FIFTH & UNION | RAINIER SQUARE REDEVELOPMENT  
Early Design Guidance Submittal #2

PROJECT #3017644

July 25, 2014

This document has been prepared in response to the Early Design Guidance of the Downtown Design Review Board, as published in minutes of the meeting held on June 17, 2014. In that meeting, priority design guidelines were identified along with recommendations of the Board.

View of Open Space Adjacent to Existing Rainier Tower

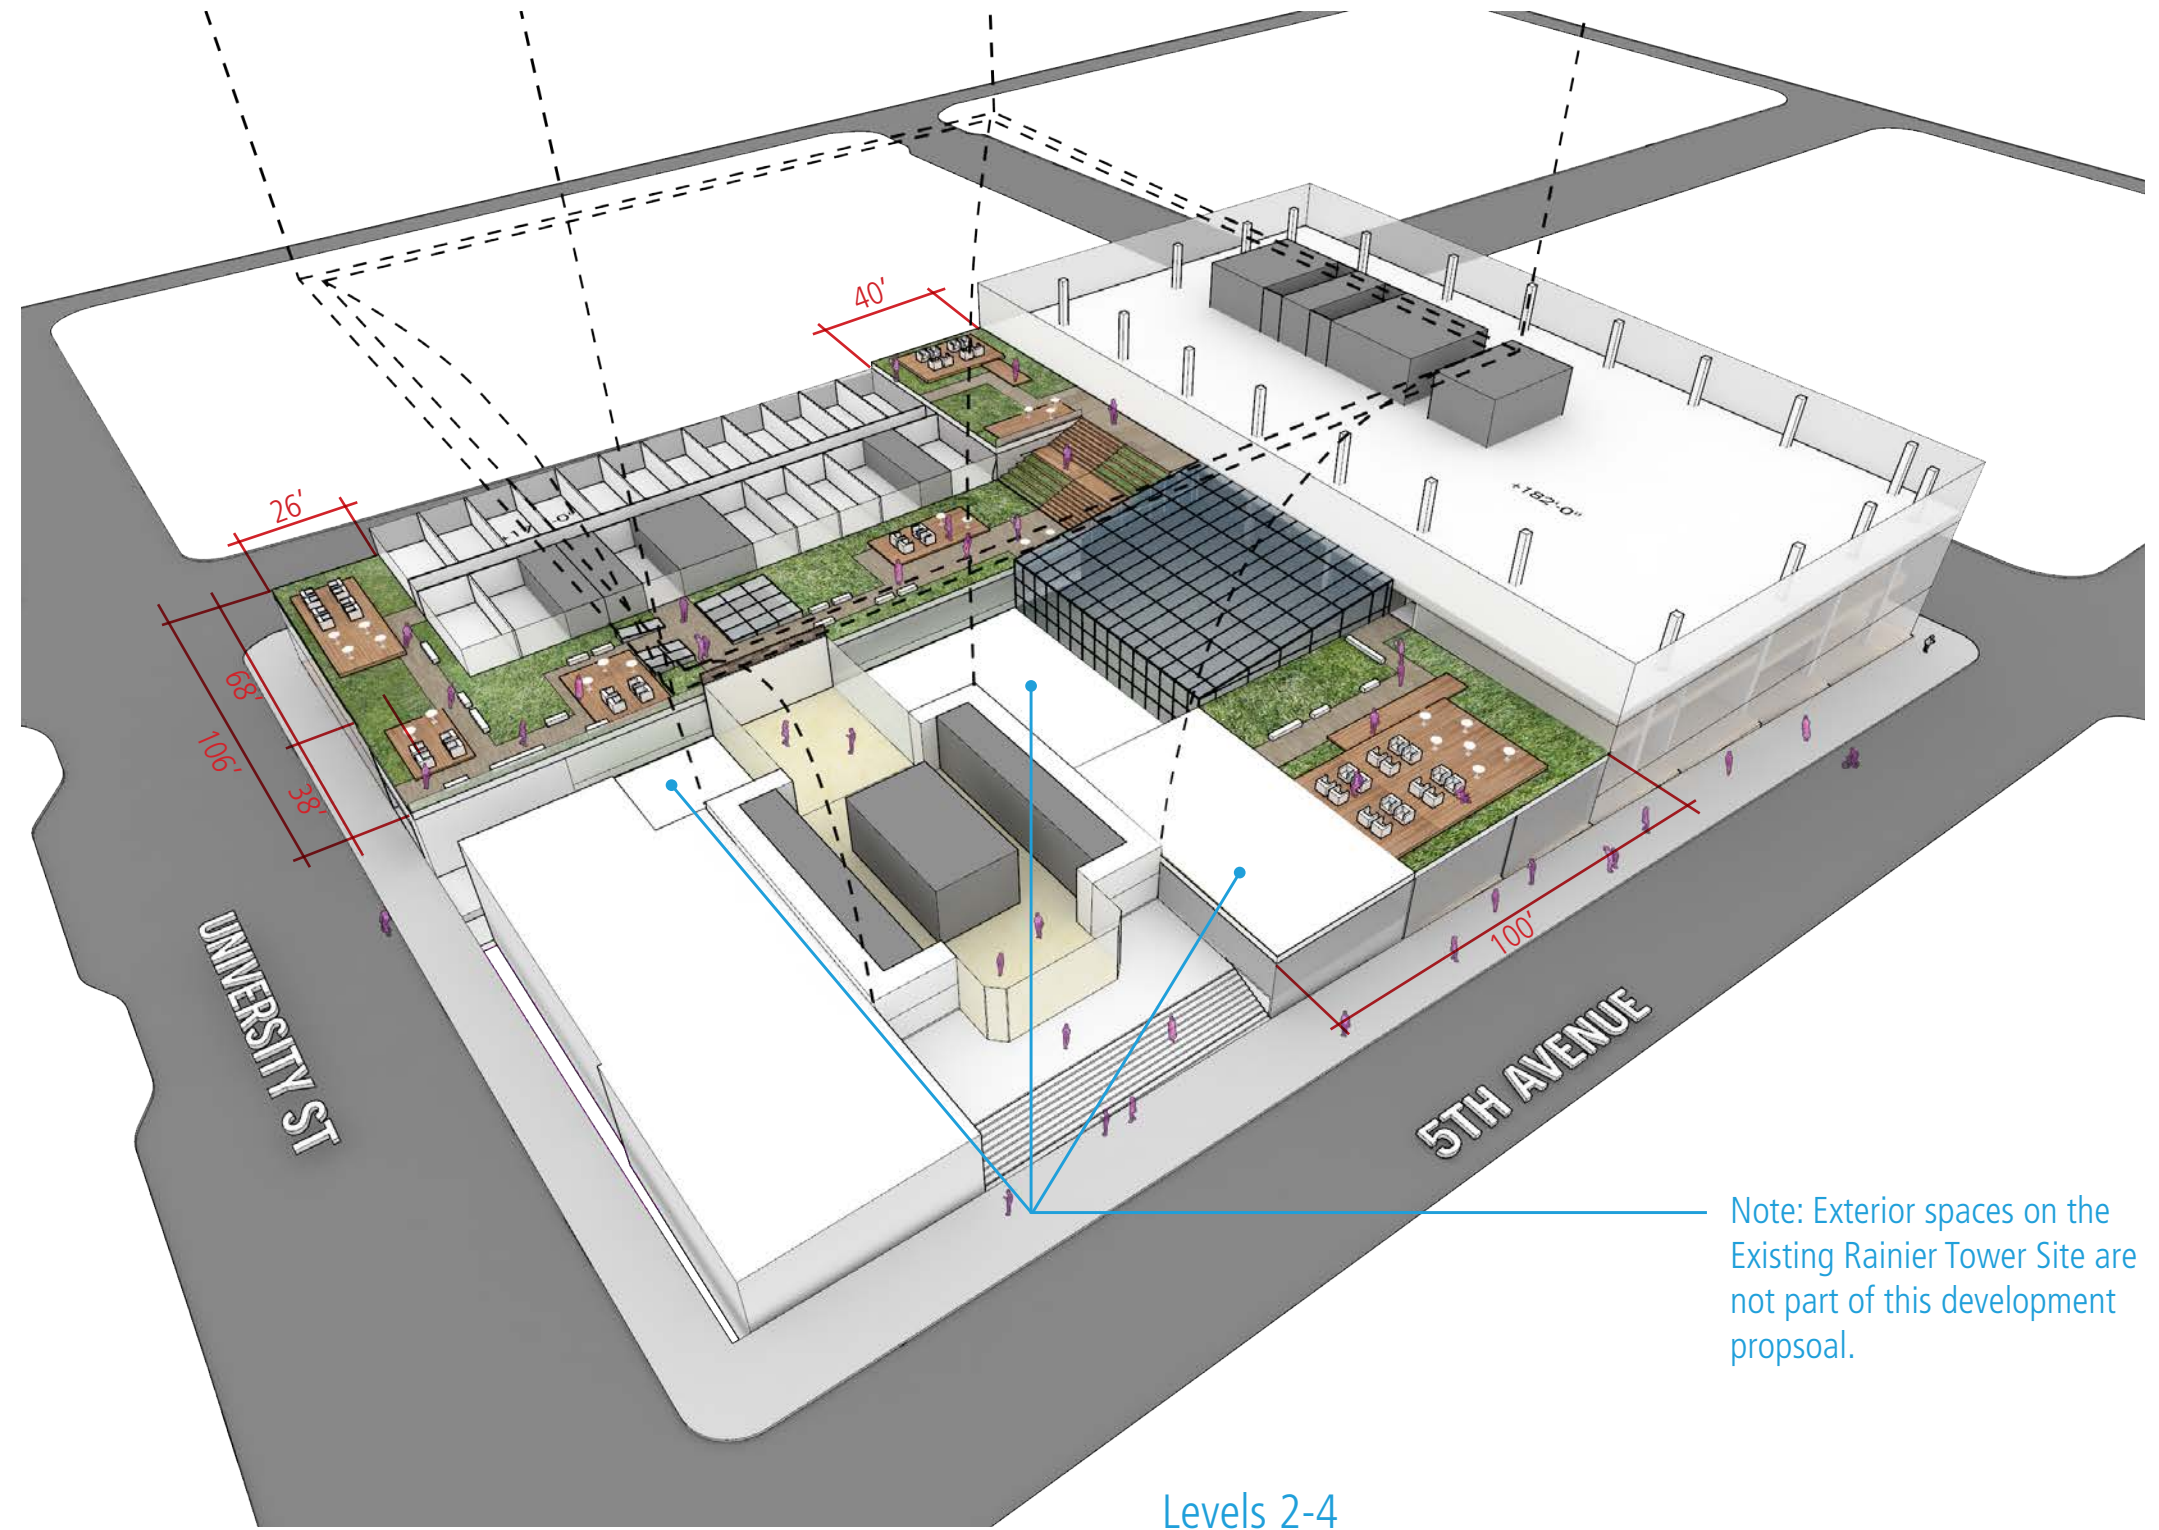
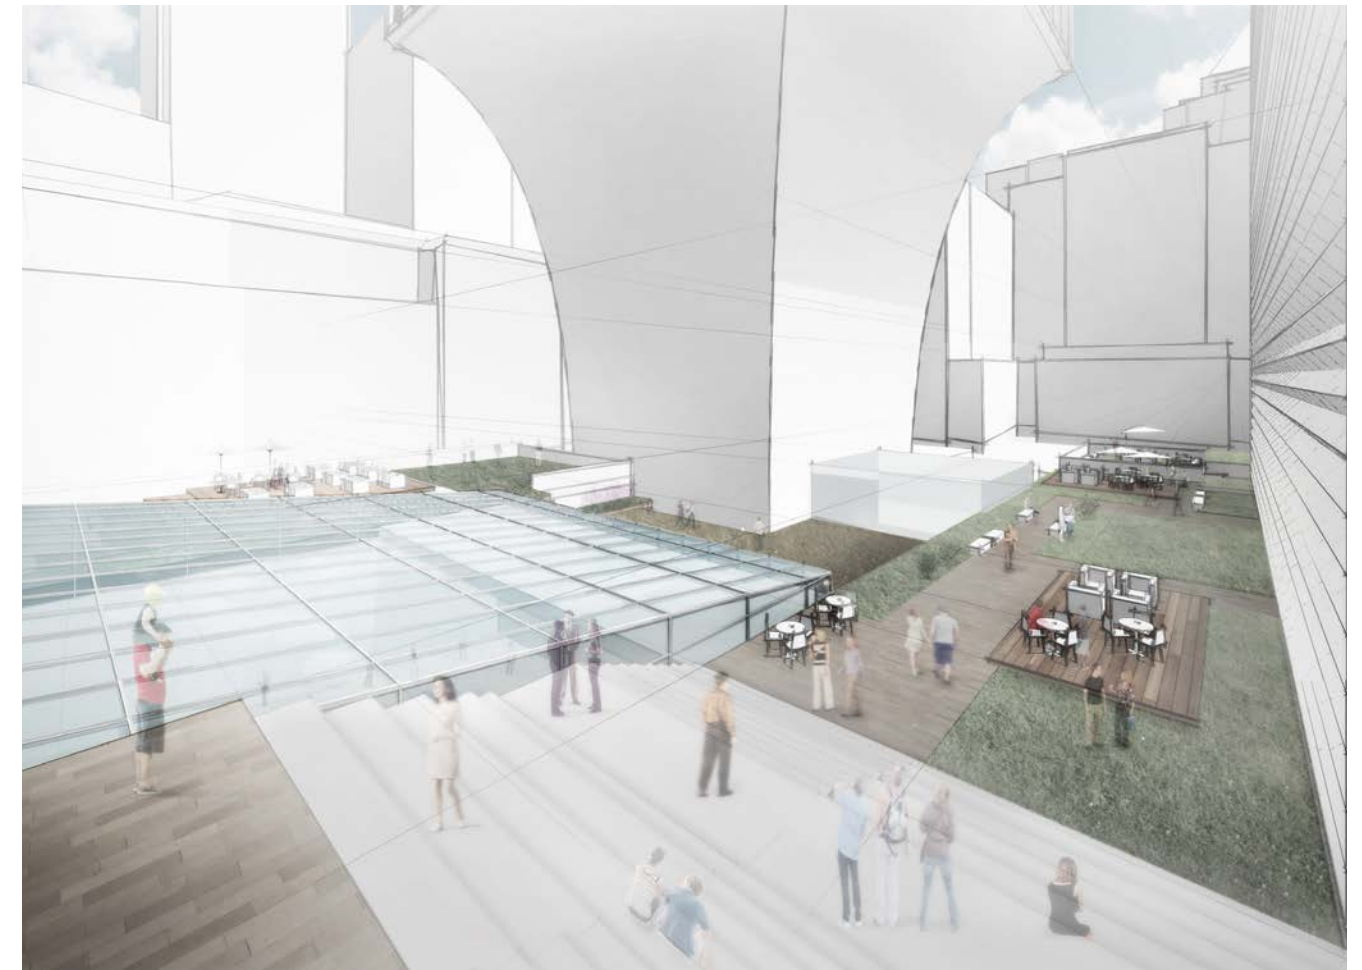
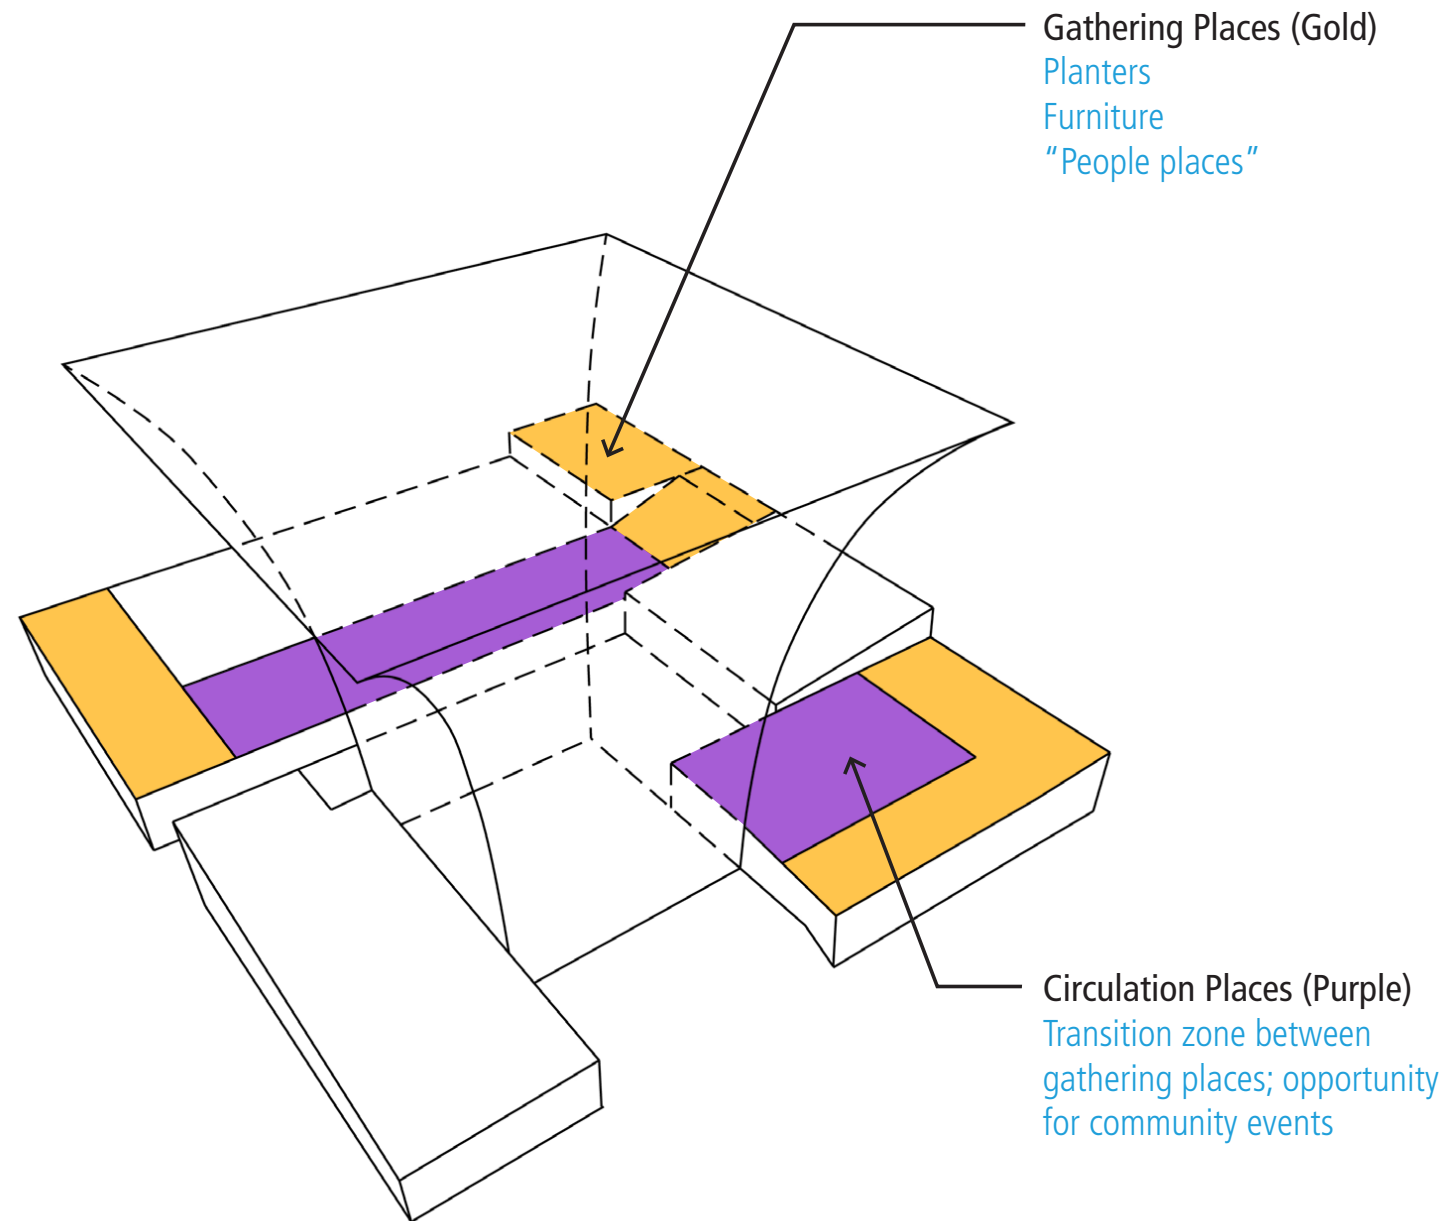
The desire for a coherent spatial arrangement of the masses at the lower levels or pedestrian realm of the complex corresponds to a second Board interest---that open space, whether private, public or a mix, has an outward presence at or near the streetscape. The applicant could consider the placement of open space at street level as an entry plaza(s) or above the plinth to exert itself in more compelling ways upon the pedestrian experience than the green swaths illustrated (p. 45) in the EDG booklet. Interstitial or negative space introduced by Rainier Tower's idiosyncratic base ought to be complemented by the massing of the new structures. The insertion of new volumes can serve to expand and shape this space into a definable open area. By giving the podium of the Rainier Tower breathing room, the development can celebrate a significant Seattle structure, supplements its visual dynamism and creates a meaningful space that defines the lower realm where the three major buildings meet.

Open space provided at the lower levels of the proposed development has been designed to leverage the unique features of the site's urban context. Open space will be aggregated at the base of the new development to create a series of open spaces envisioned as "lifted urban gardens", providing important visual connection from the pedestrian realm at street level to the sculptural base of Rainier Tower as well as to the light, air, and activity occurring at the new "plinth". A retail-oriented, glass-ceilinged central atrium space in the new development will also afford dramatic views of Rainier Tower and the surrounding context. As discussed in the response to guideline A-1, the massing of the office / residential tower and the hotel have both been adjusted to respond directly to guidance received from the board.

This open space will provide a unique sense of place, to respond and interact with Rainier Tower, and to enhance the downtown urban environment.
